**MODIFICATION WORK ORDER**

**MODIFICATION OF  
M93 PALADIN MUZZLE VELOCITY SYSTEM  
(NSN 1290-01-412-5759)  
(EIC: 3TC)**

HEADQUARTERS, DEPARTMENT OF THE ARMY, WASHINGTON D.C.

15 December 2005

FIGURE 1

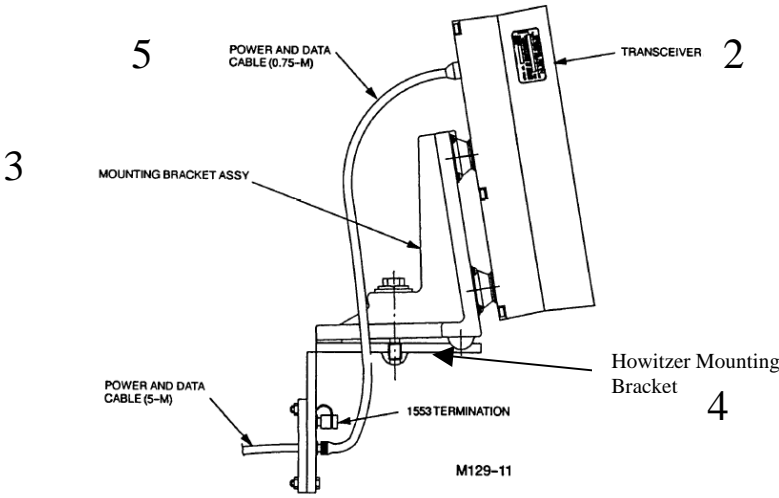
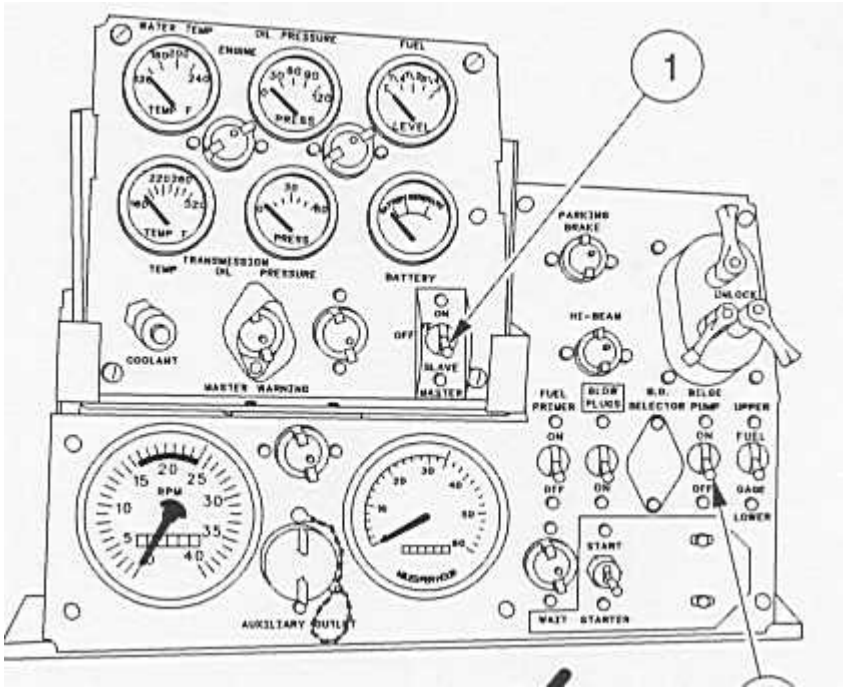
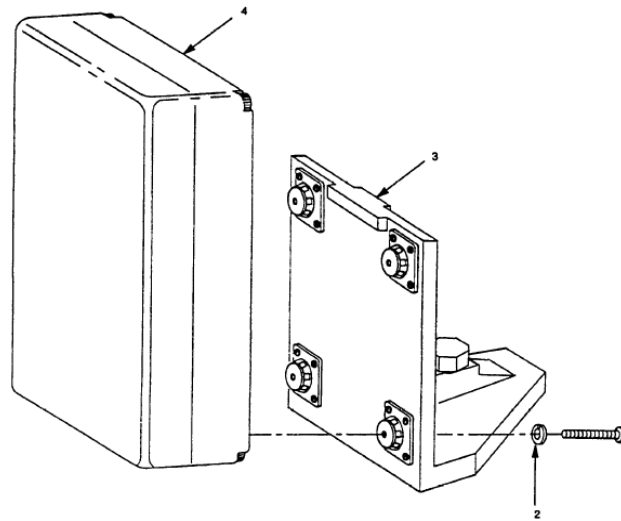
**c. PROCEDURES FOR REMOVAL:** The M93 Paladin Muzzle Velocity System must be removed from the howitzer in accordance with the following steps and figure 1:

- (1) Ensure that the vehicle **MASTER** switch (1) is in the **OFF** position.
- (2) Disconnect W92 power and data cable (5) from M93 radar antenna transceiver (2).
- (3) Remove antenna-mounting bracket (3) from howitzer mounting bracket (4) by unscrewing the hex head mounting bolt (fig. 3, item 1) securing the two brackets together.

**f. INSTALLATION:** Install the transceiver and mounting bracket to the howitzer in accordance with the following steps and figure 1.

(1) Ensure that the vehicle **MASTER** switch (1) is in the **OFF** position.

(2) Position antenna-mounting bracket (3) on howitzer bracket (4).

(4) Install mounting bracket with attached transceiver to the howitzer's bracket and torque main bolt to between 450 and 500 in-lb (37.5-41.67 ft-lb).

(5) Connect W92 power and data cable (Fig. 1, Item 5) to M93 (upgraded) transceiver (Fig. 1, item 2).

**Figure 2**

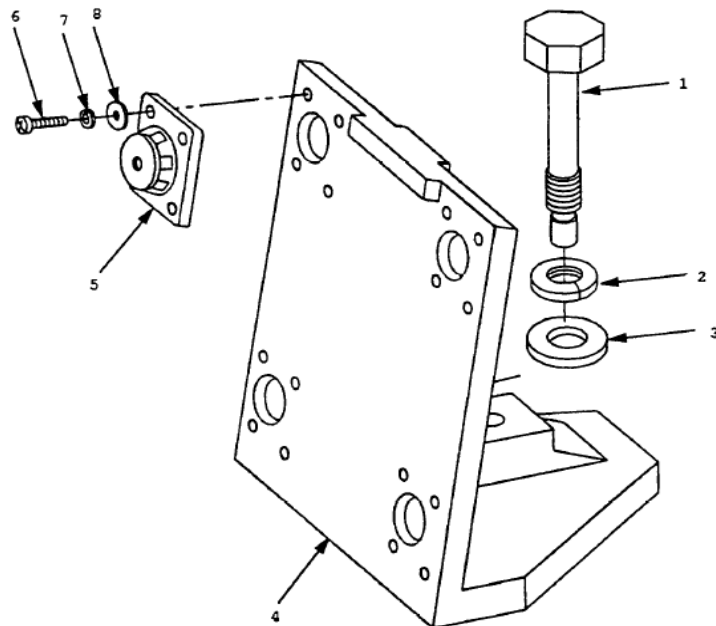
(1) Transceiver from antenna-mounting bracket. Remove the following parts in accordance with the following steps and figure 2:

(a) Unscrew and remove four screws (1) and four lock washers (2) that secure transceiver (4) to bracket assembly (3). See paragraph 8d regarding disposition of hardware.

(b) Remove and set aside for disposition per paragraph 8d, the transceiver (4) from bracket assembly (3).

(2) Transceiver to antenna-mounting bracket. Install the following parts in accordance with the following steps and figure 2:

(a) Correctly position transceiver (4) on bracket (3).

(b) Install four new screws (1) and four new lock washers (2).

(c) Using a hex head torque wrench (table 5), tighten each mounting bolt to between 60 and 70 in-lb (5.00-5.83 ft-lb).
